December 15, 2009

**Re: Panoche Energy Center Project (06-AFC-5C)
Petition to Amend**

REVISED FIGURES

Figure 1.3-1 PROJECT ARCHITECTURAL RENDERING

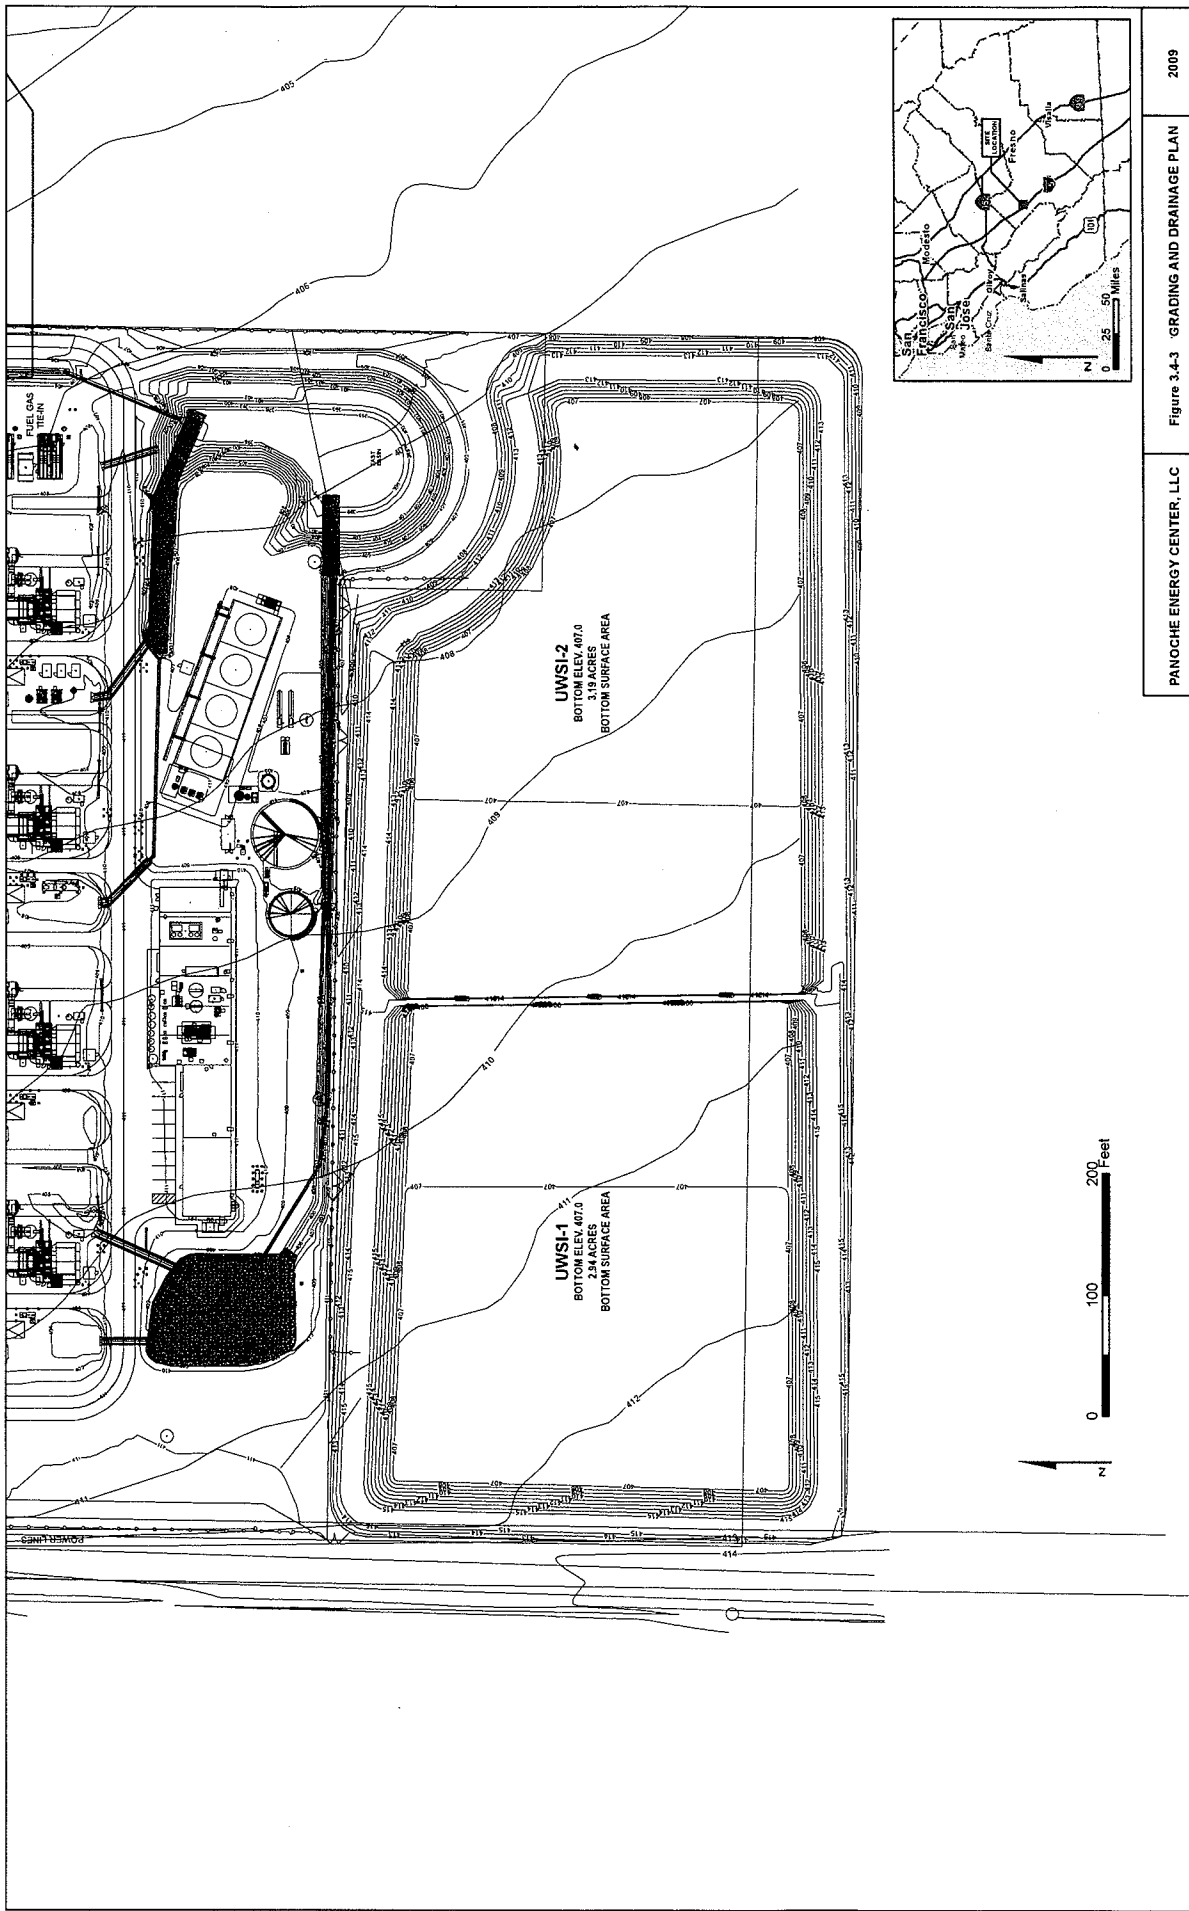
In light of the foregoing, the following figures and tables have been updated to reflect the refinements, copies of which are attached hereto for your convenience: Figure 1.3-1; Figure 3.4-1; Figure 3.4-3; Figure 5.13-2; Table 5.2-1; Table 5.2-2; Table 5.2-3; Table 5.2-4; Table 5.2-5; Table 5.2-6; Table 5.11-1; and Table 5.11-2. In addition, all of the spreadsheets contained in Appendix A – Air Quality contain revisions. Thus, a revised Appendix A is also attached hereto.

PANOCH ENERGY CENTER, LLC Figure 3.4-3 GRADING AND DRAINAGE PLAN 2009

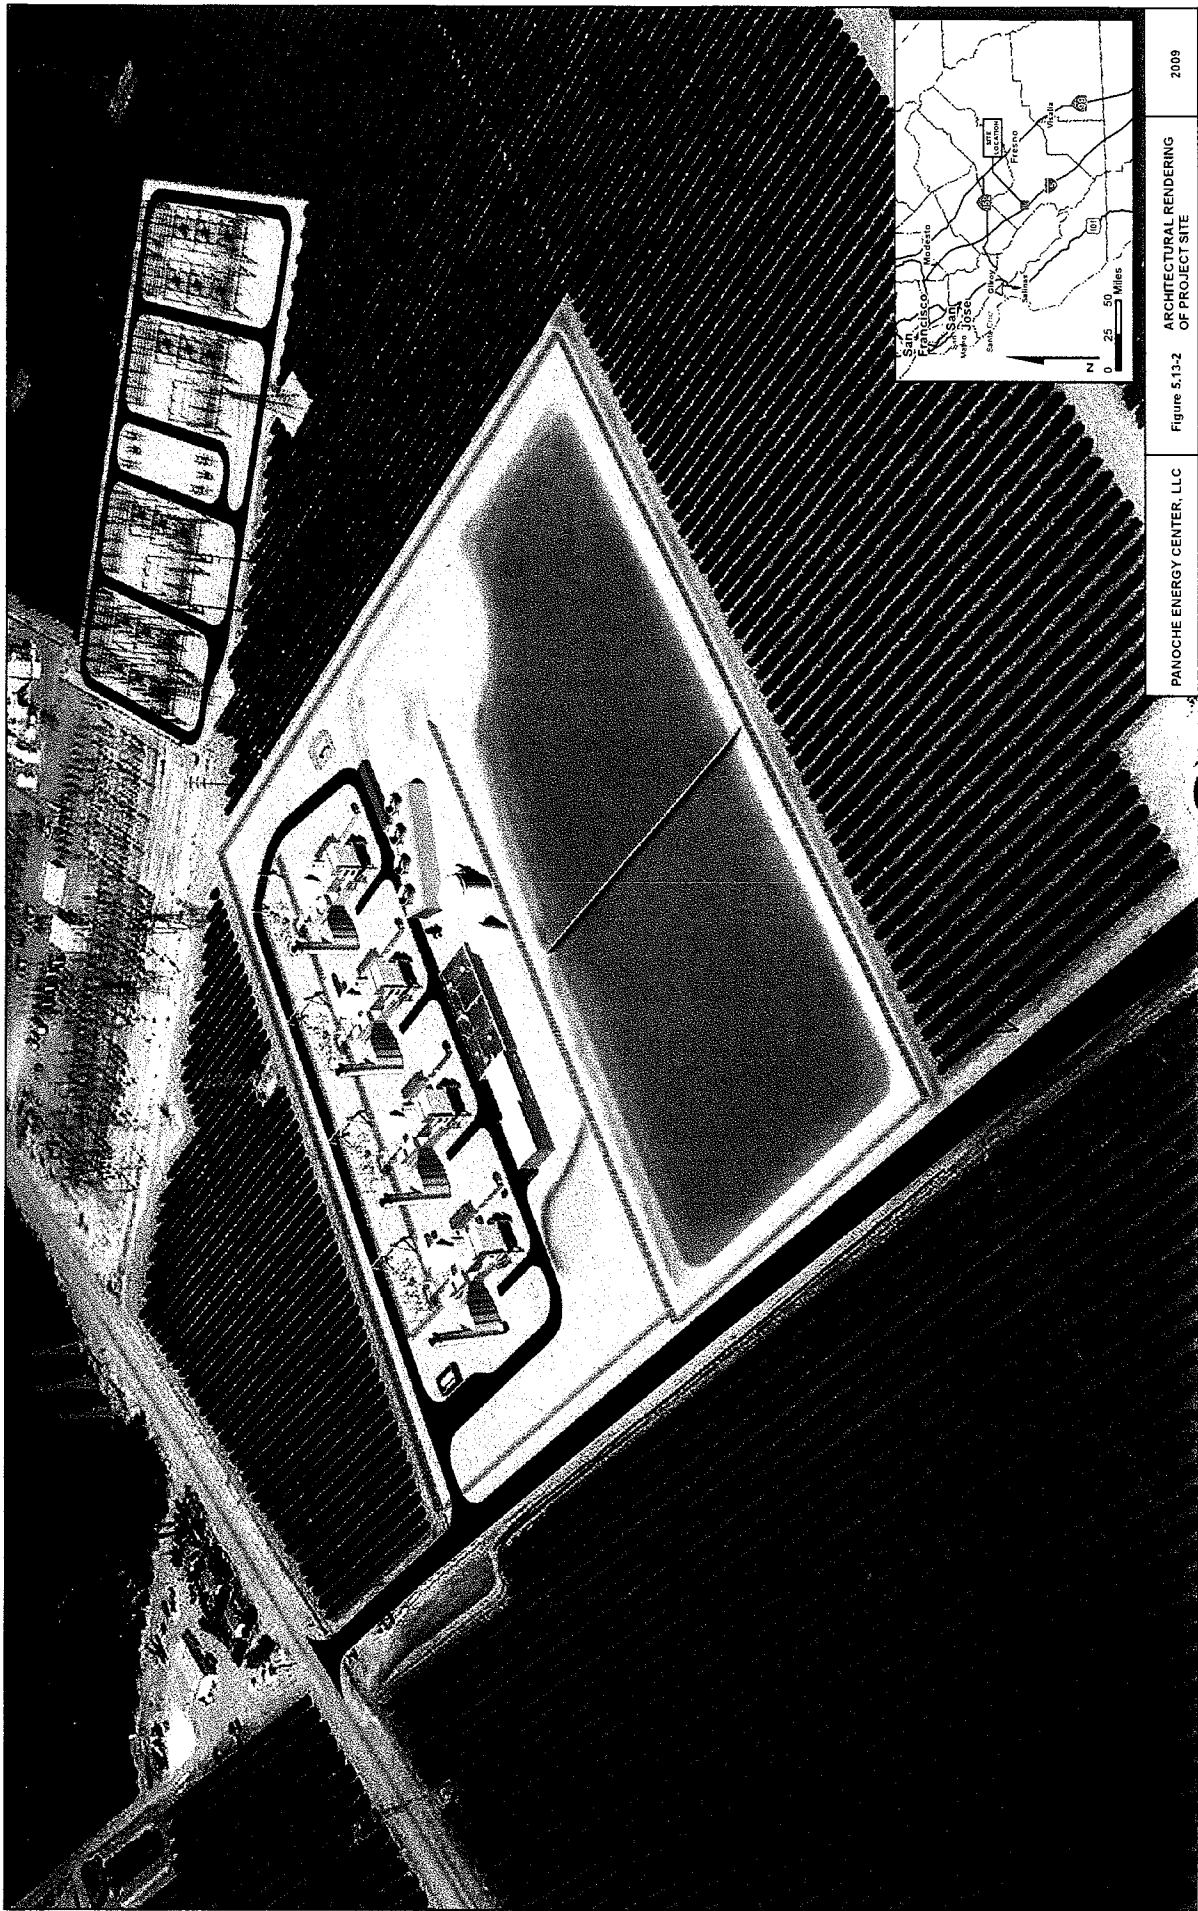
After receiving and reviewing a Report of Waste Discharge ("ROWD") from PEC, the Regional Board requested PECL to provide additional information. During the compilation of such additional information, PECL determined that the westernmost unlined surface impoundment should be two feet deeper than originally designed to ensure adequate freeboard at all times. In addition, PECL has determined that the best way to meet freeboard requirements is to modify the originally proposed internal earthen center barrier between the two impoundments to sheet piling, concrete, or another durable material.

Specifically, UWSI-1 is designed to have a bottom surface area of 2.94 acres and UWSI-2 is designed to have a bottom surface area of 3.19 acres. The westernmost UWSI will be built to an eight-foot depth and the easternmost UWSI will be built to a six-foot depth. Both UWSI will have the same bottom elevation, and will allow for at least two feet of freeboard throughout the year. To meet the freeboard requirements, the center barrier between the two UWSI will be constructed of sheet piling, concrete or another durable material that will be approximately 6 feet high by 2 feet wide. As previously designed, the UWSI also will have a 20-foot wide surrounding berm. The berm width will allow for maintenance vehicle access. Berm heights will measure six feet from the top of the berm to existing ground elevation. The southern edge of the south berm (the bottom edge of the outer slope) is along the edge of the property boundary. In addition, a temporary warehouse foundation, which is presently within UWSI-1's
